21 March 2006

71-5800

Procedure	QA Program for 20WC Users
Revision	1
Date	March 2006
Approval	Jerry P. Wiza, President

RAM Services, Inc.
Specification 20WC Protective Wooden Jacket
Quality Assurance Program

Figure 1. RAM Services QA Organization

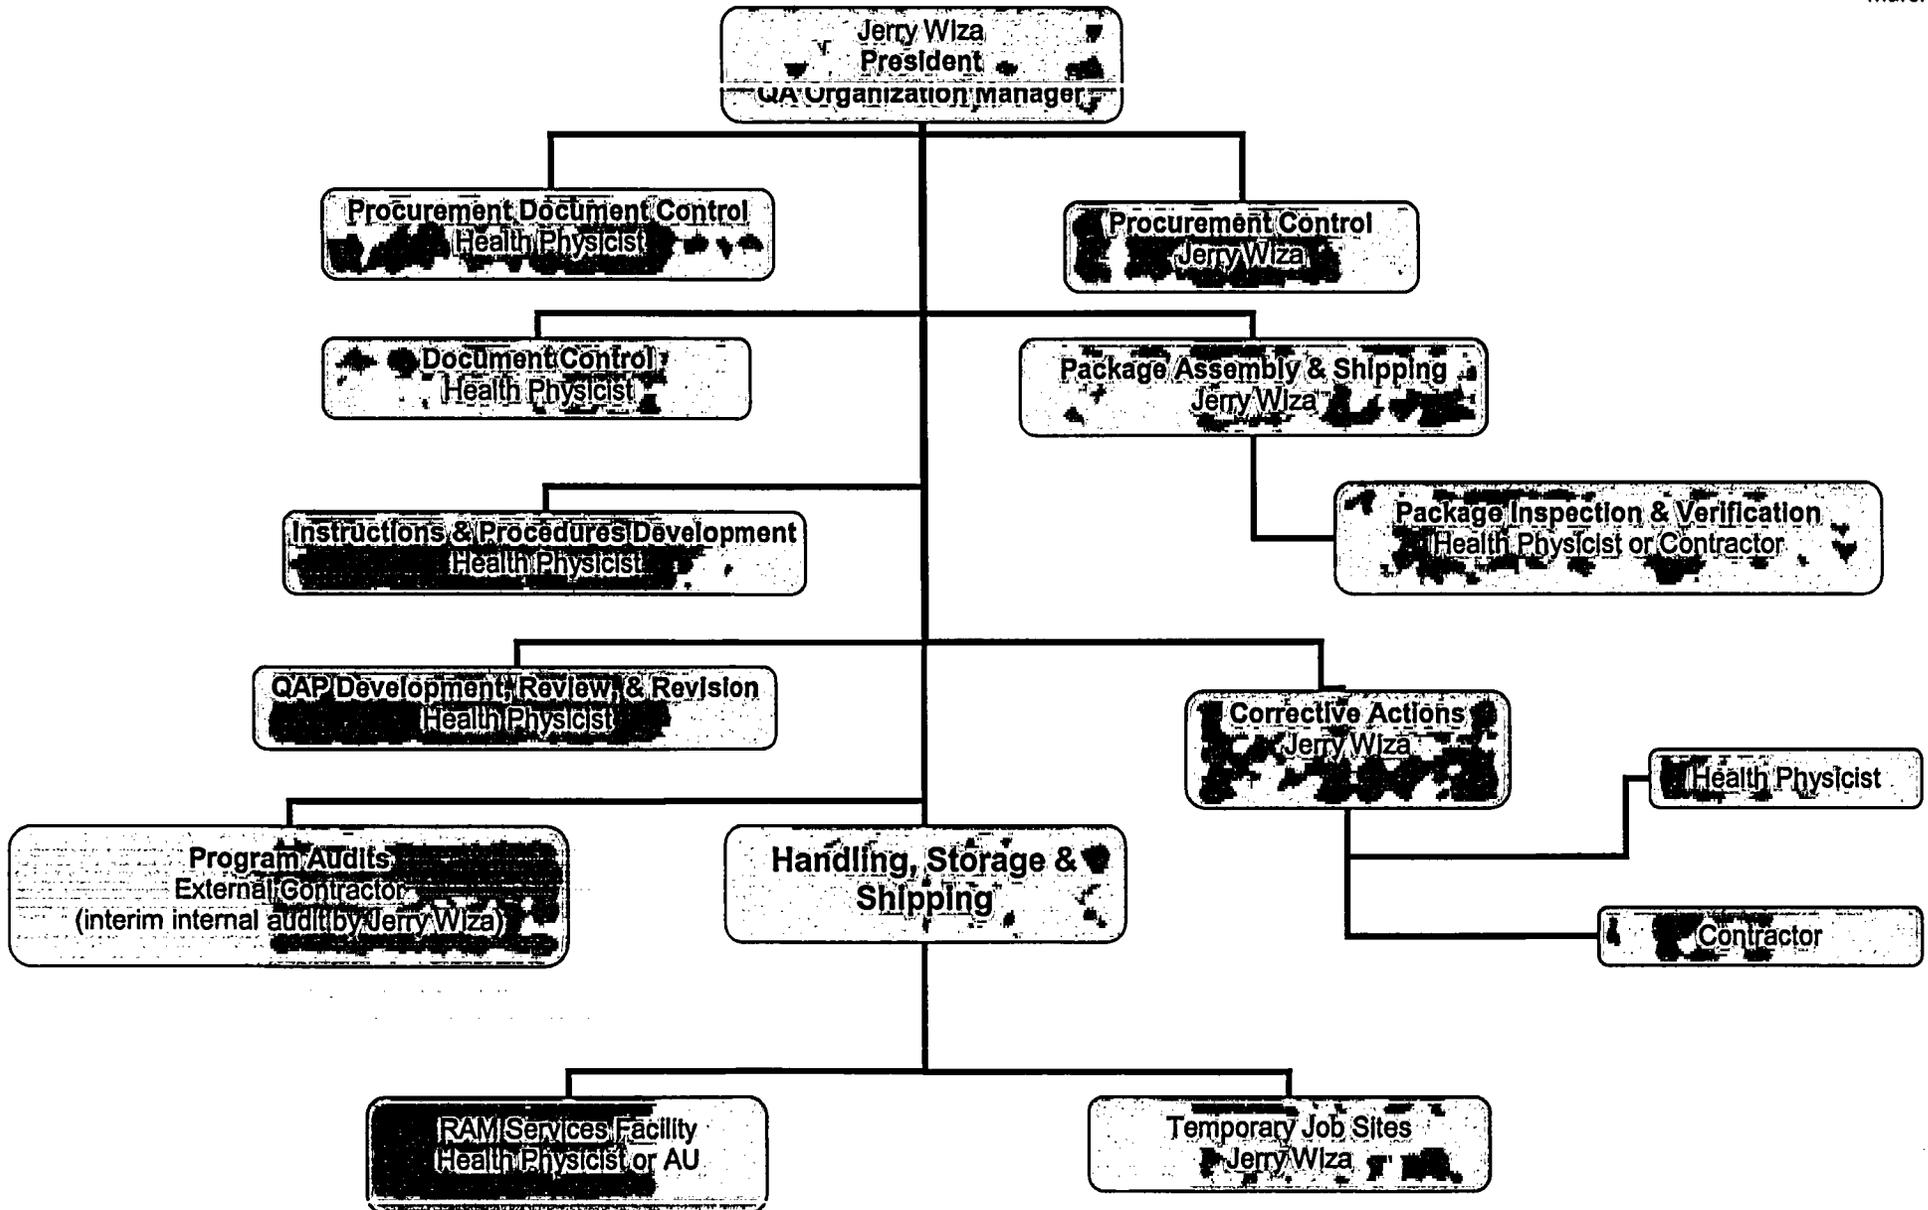
Question 1. Organizational Structure.

We concur that having one person attempt to perform all the QA functions, as well as prepare the package, is inadvisable and contrary to the clear intent of 10 CFR 71.103(d).

Consequently, we have substantially revised our program in order to distribute Quality Assurance Program [QAP] functions between the President of RAM Services and his professional staff, a health physicist. We have tried to observe the principle that “[c]onformance to established requirements is verified by individuals and groups that are not directly responsible for performing the work.” [Reg. Guide 7.10, Rev. 2, at p. 5].

We have prepared an expanded organization chart [QAP-1-1, which is also incorporated into our revised Quality Assurance Program, [QAP-2-1], submission, to delineate the re-distribution of responsibilities, which is discussed extensively in Section 1 of the revised program.
